### APPEAL SUMMARY

**Appeal ID:** 19041

**Project Address:** 631 SE Taylor St

**Building/Business Name:** The Rose Apartments

REVISIONS:

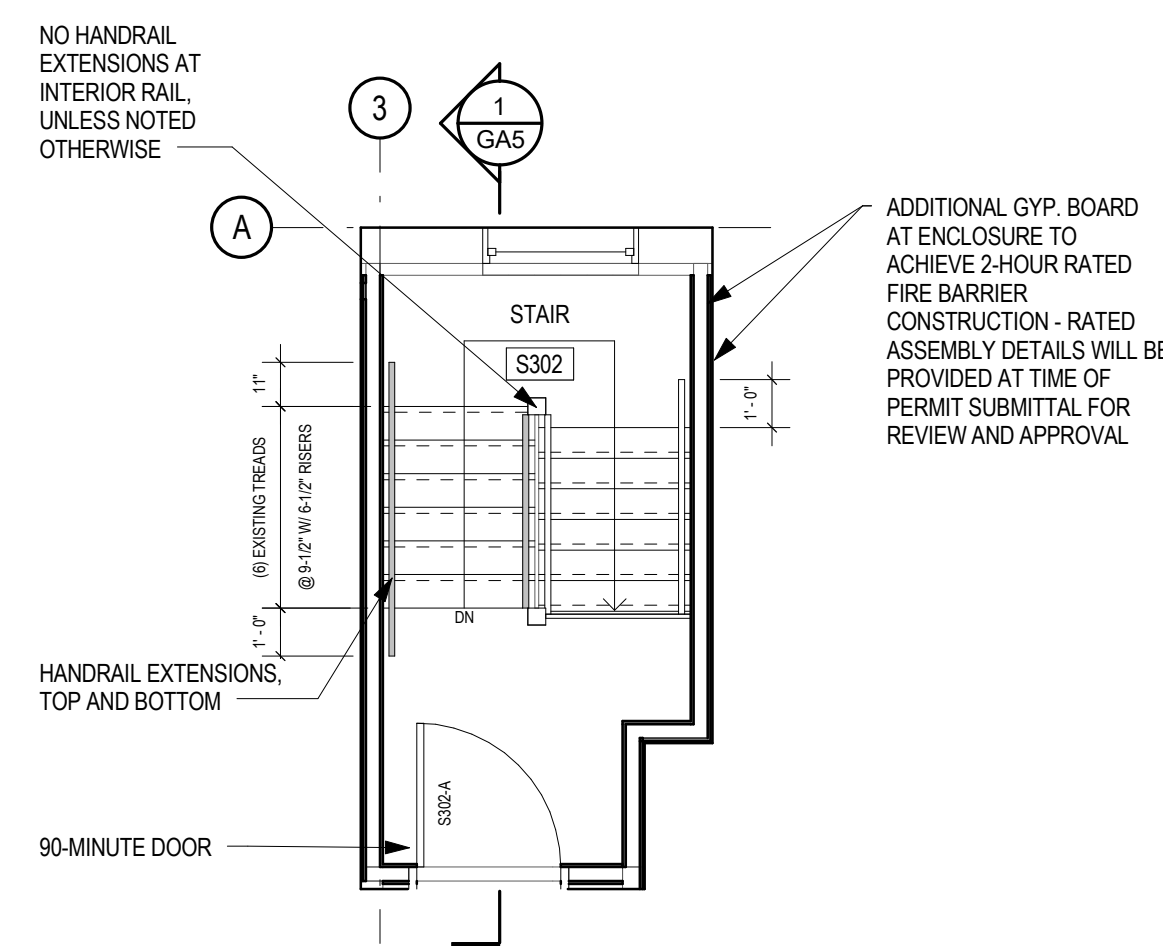
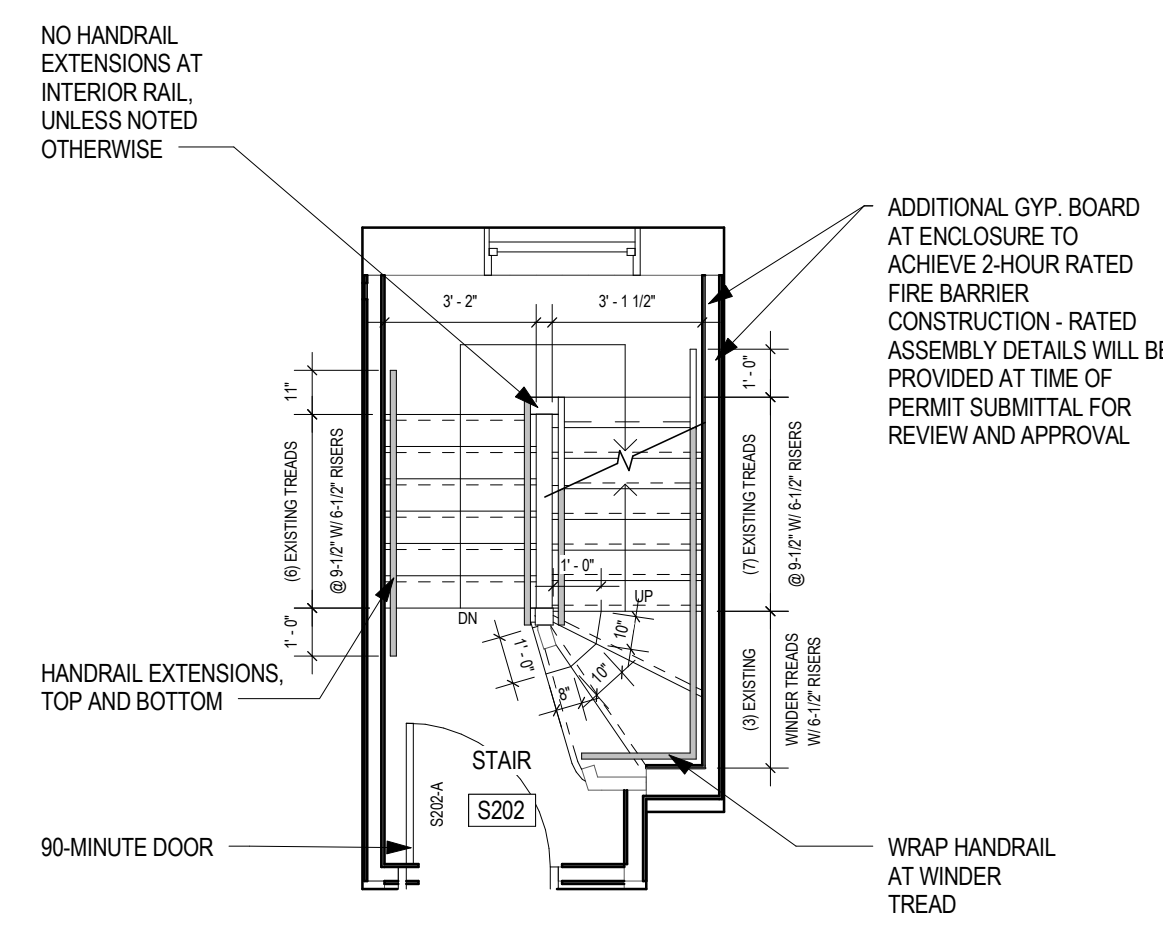
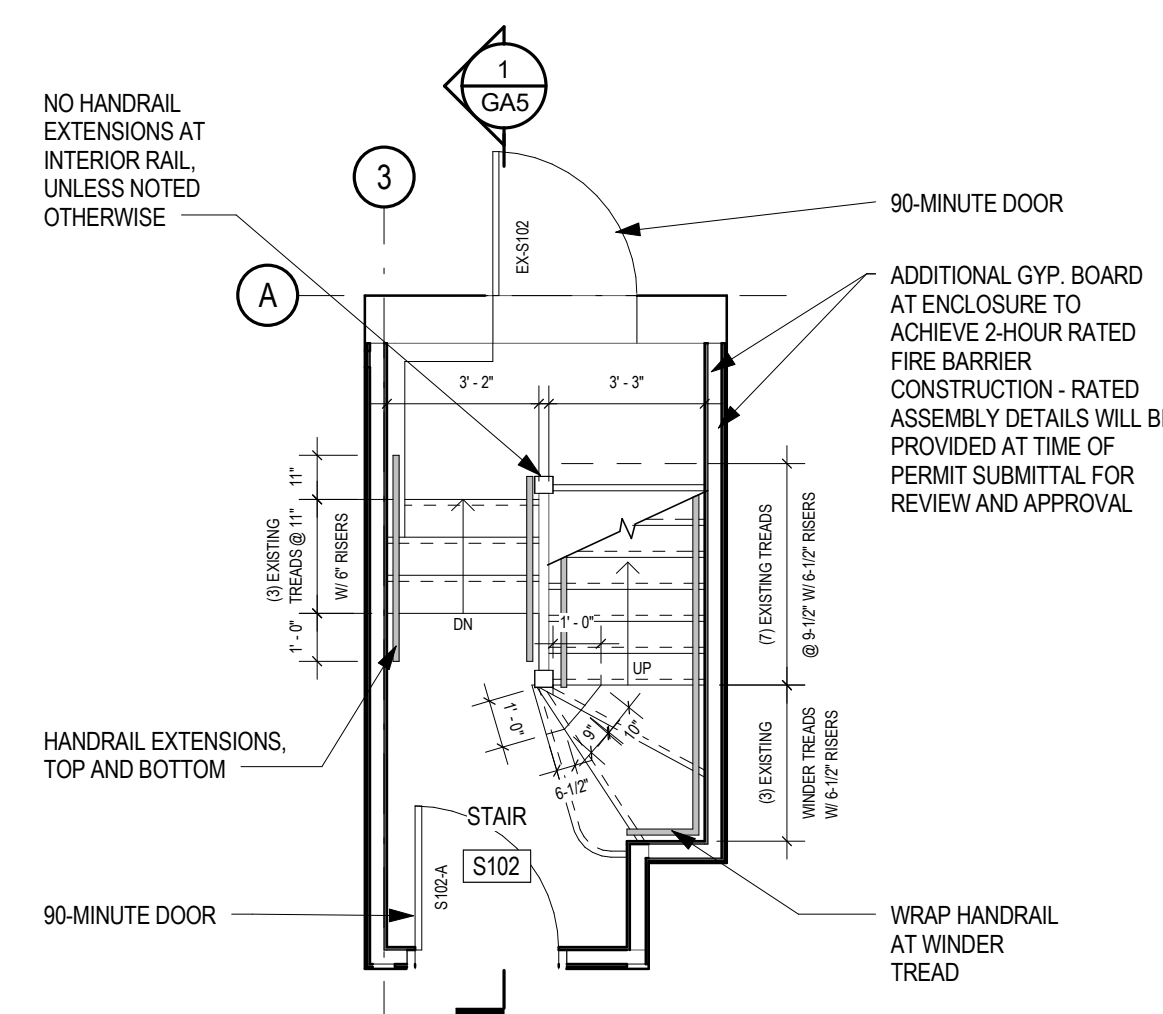
See Details 2, 3, 5 and 8/GA4, and Details 1, 2, 3 and 5/GA5.

<b>Code Section</b>	1012.6 Handrail Extensions
<b>Requires</b>	Where handrails are not continuous between flights, the handrails shall extend horizontally at least 12 inches beyond the top riser and continue to slope for the depth of one tread beyond the bottom riser.
<b>Proposed Design</b>	<p>ORIGINAL APPEAL TEXT: Within the existing northeast and northwest exit stairs, compliant top and bottom rail extensions will be provided where the plan configuration allows. Where there is not room for extensions due to existing conditions and space constraints, extensions will not be provided. See Details 2, 3, 5 and 8/GA4 for more detailed information.</p> <p>RECONSIDERATION TEXT: Within the existing northeast and northwest exit stairs, compliant top and bottom rail extensions will be provided where the plan configuration allows. Handrails will wrap the wall at winder tread locations. Where there is not room for extensions due to existing conditions and space constraints, extensions will be provided to the maximum length possible. See Details 2, 3, 5 and 8/GA4 and 1, 2, 3, 4 and 5/GA5 for more detailed information.</p>

<b>Code Section</b>	Table 705.8 Allowable Openings Based on Fire Separation Distance
<b>Requires</b>	Unprotected openings less than 3' from a property line are not permitted.
<b>Proposed Design</b>	<p>ORIGINAL APPEAL TEXT: The six unprotected operable windows at the west property line shall remain. The building shall be equipped with a full NFPA 13 sprinkler system throughout. See GA2 and GA3.</p> <p>RECONSIDERATION TEXT: The six unprotected operable windows at the west property line shall be replaced with UL listed 1-hour fire-rated operable windows with a fusible links that close the windows in the event of a fire. The building shall be equipped with a full NFPA 13 sprinkler system throughout. See GA2, GA3 and GA5.</p>

**2. Winder treads in 2 egress stairs: Granted as proposed.**

**3. Omission of handrail extensions in 2 egress stairs: Granted as proposed.**

**4. Proposed UL listed 1 hour fire rated operable windows with self closing mechanisms at property line: Granted as proposed.**
